Technical Bulletin

New Lift Bar Configuration

FM-7.5-202
Rev A
08/29/05

New Lift Bar Configuration

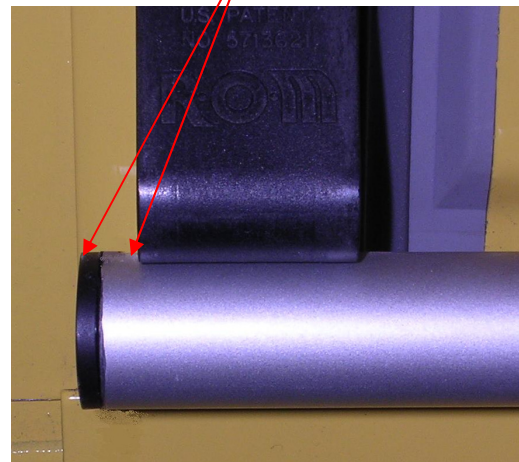
Our lift bar has been reconfigured so that the magnet in the lift bar will more consistently work with out-of-tolerance door openings.

Before, if a compartment were made more than 1/4" too large, the magnet may not have consistently triggered the switch. This would require the installation of a shim to shove the door to the "switch side" of the compartment.

Now, our new lift bar configuration will eliminate the need for shimming. If the door will physically fit and operate with an out-of-tolerance door opening, the Door Ajar Switching System (DASS) will also work. This is accomplished by extending the length of the lift bar by approximately 5/16" past the strike blocks on each side. Also, the end caps have been redesigned to better match the profile of the lift bar.

Lift Bar Has Been Extended
